From: Dearnell, Lori
Sent: Friday, May 03, 2013 2:07 PM
To: jrheppner@aep.com; tlhairston@aep.com; Buskirk, Doug (Doug.Buskirk@dot.state.oh.us); Pack, Doug (Doug.Pack@dot.state.oh.us); Steven.Pennington@dot.state.oh.us
Cc: Hyre, Brad; Dearnell, Lori
Subject: SCI-823-0.00: AEP Transmission Line Crossings

The SR 823 Portsmouth Bypass project has been ongoing for many years now and will soon be transitioning to alternative delivery. HDR is wrapping up involvement with the project and this email is to summarize previous correspondence and the current design regarding your facilities.

I have attached three email chains regarding the AEP transmission line crossings of the proposed SR 823 Portsmouth Bypass project. The first correspondence was with John Cookman in response to the PAVR submittal in 2005, while the second and third correspondence was with John Heppner and Dan Woeste in order to verify clearances with the Stage 1 design.

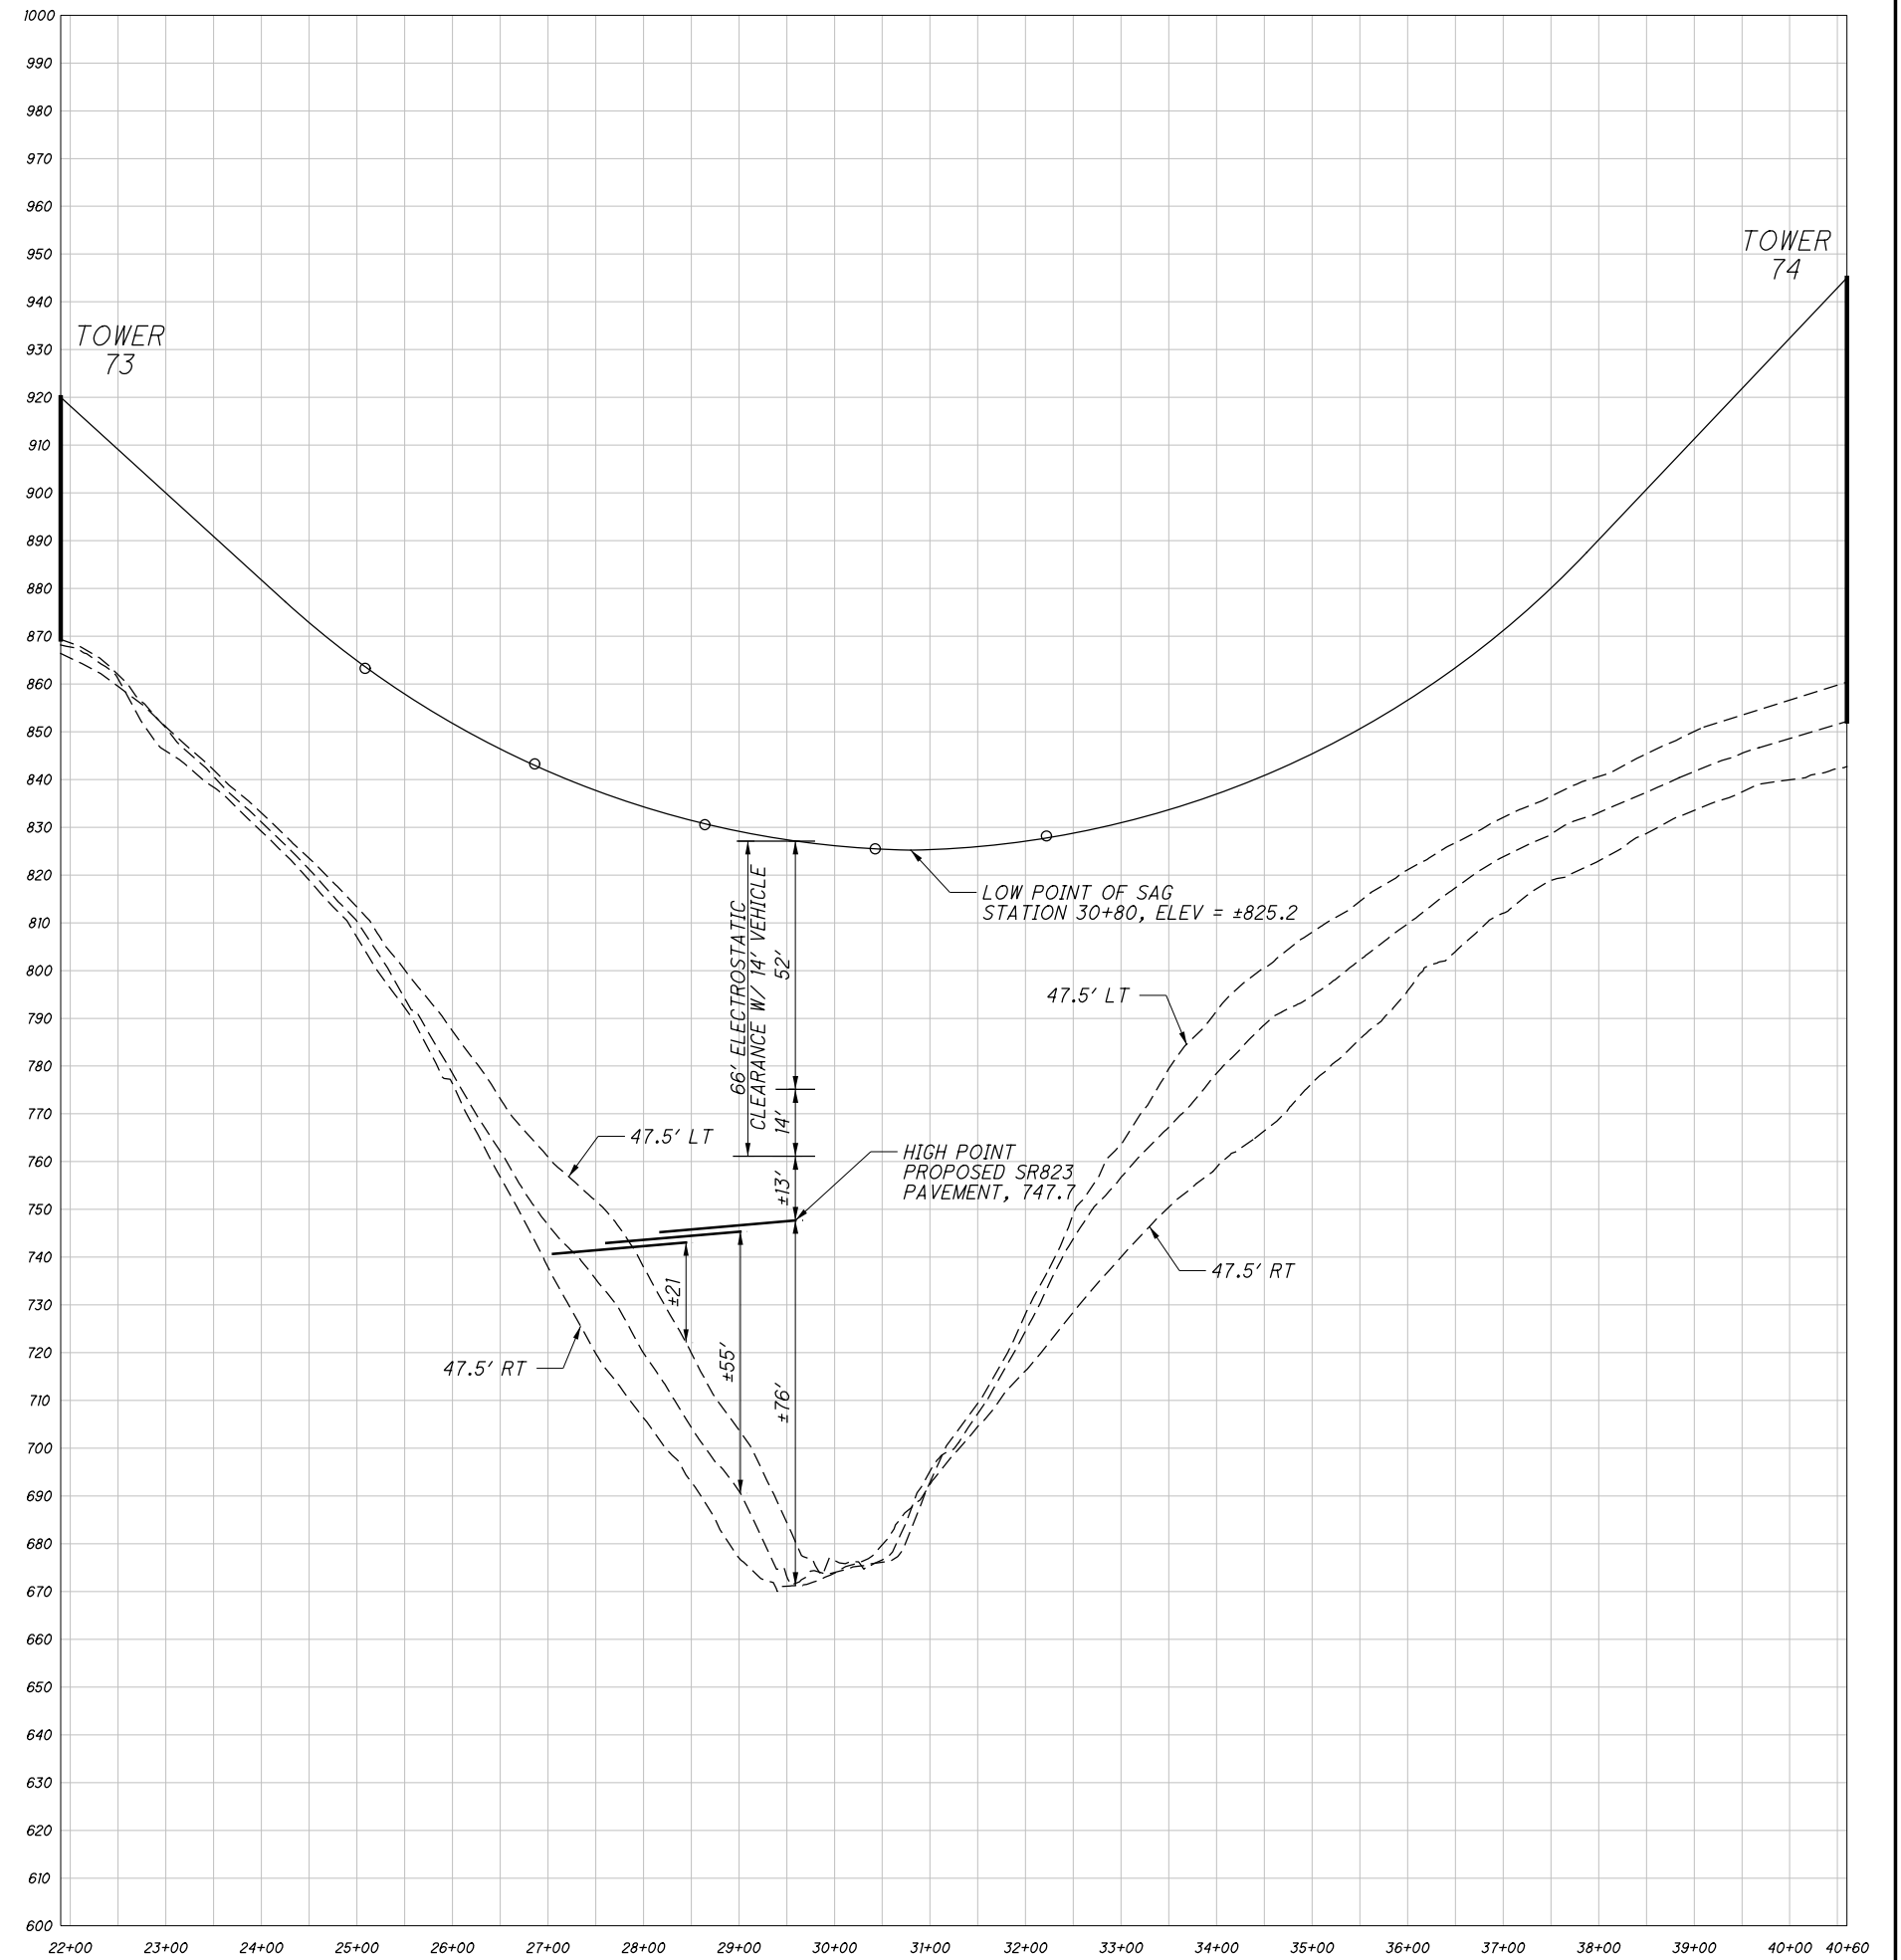
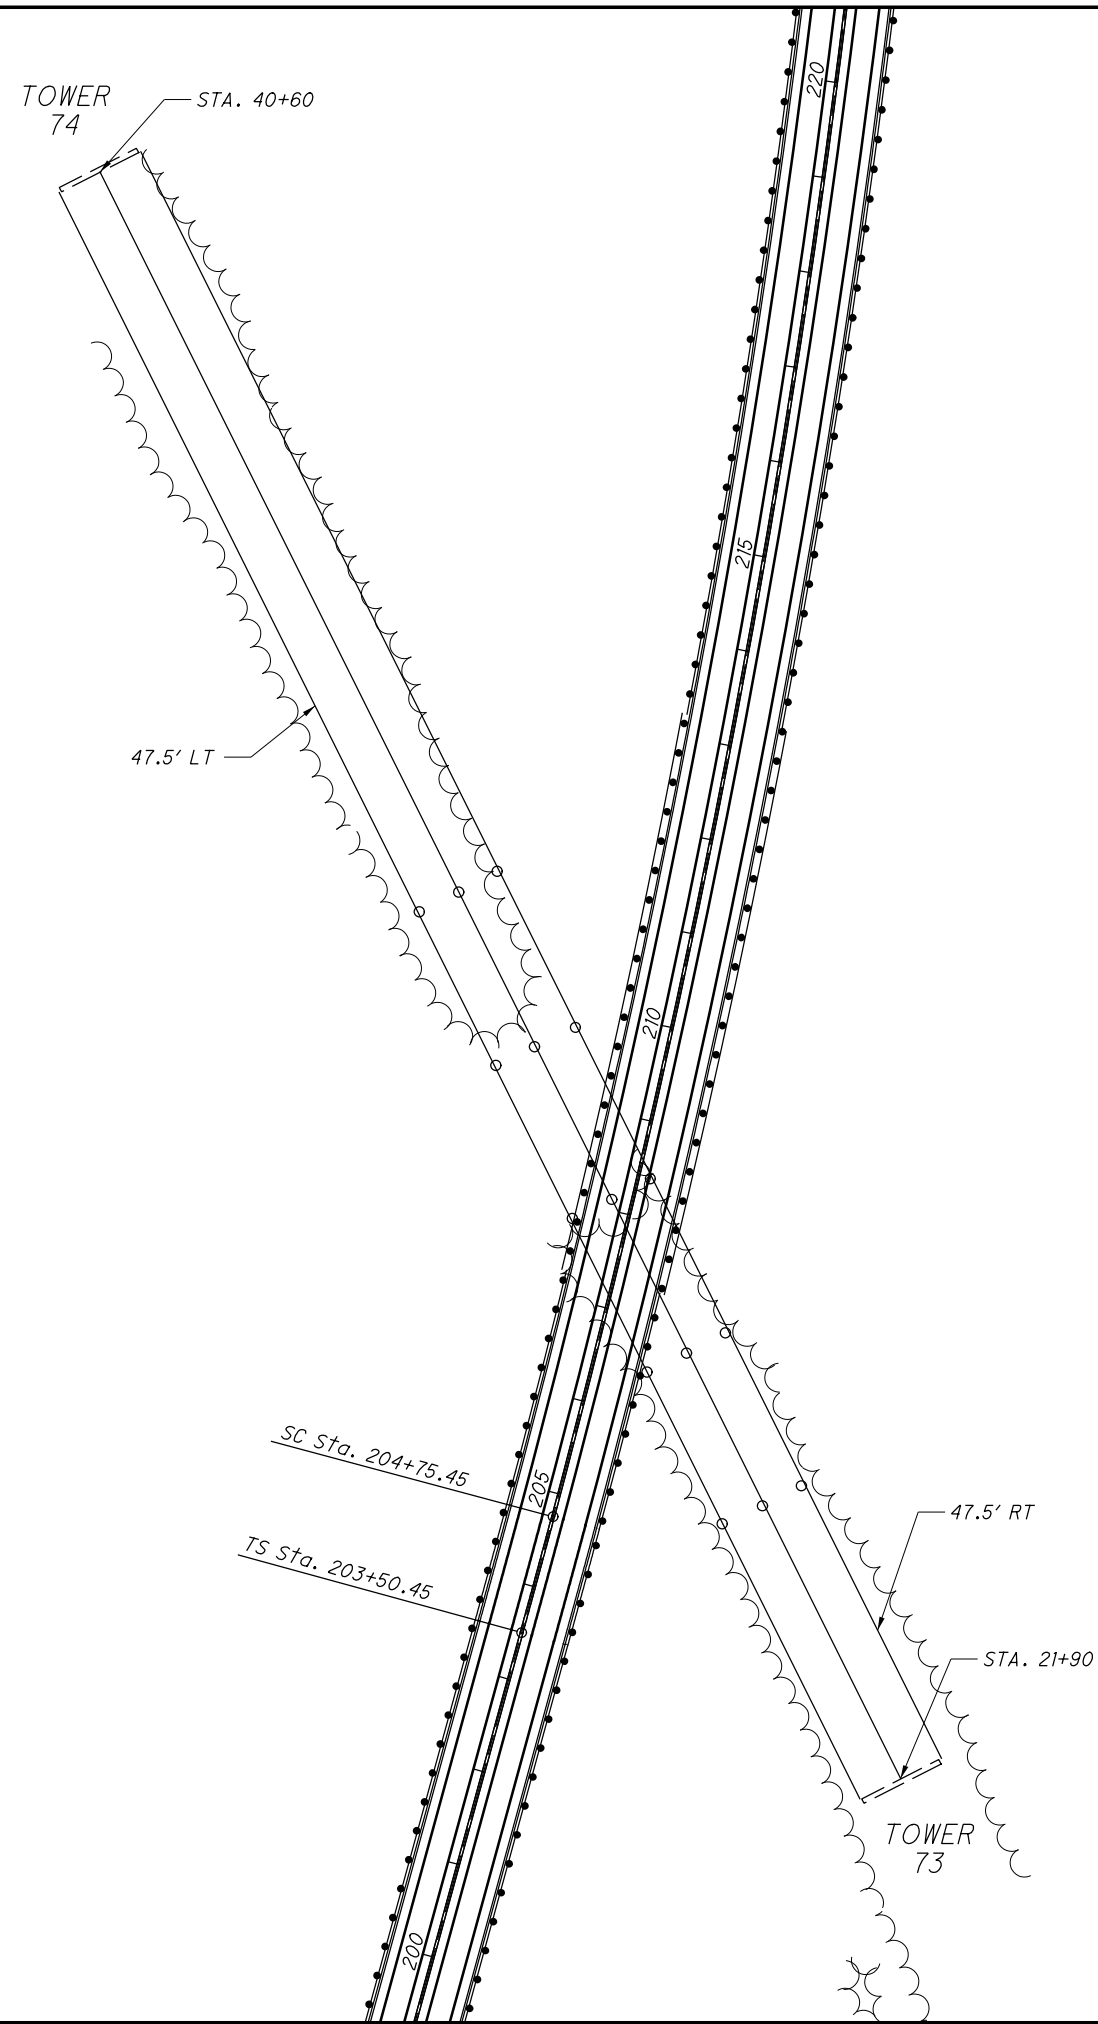
After briefly reviewing the elevations on the only profile drawing that we received (sta. 202+00 to sta. 214+50) and cross checking it to the clearance that is required, it appears that this particular span will most likely meet clearance. I would like for you to confirm this as I was only able to interpret the location of the proposed roadway based on the topography of the span.

I have attached plan and profile drawings for each of the spans that cross your planned route for the bypass. These drawings each have their respective clearance line drawn on them as required by the NESC code (as well as necessary electrostatic clearances in the case of the 765 kv line). Additionally, more detail is needed regarding the last leg of the bypass by Scioto Dale. As you can see from the attached drawing there is a lot of potential congestion/conflict with numerous poles on the Ironton - Portsmouth 69kv Line.
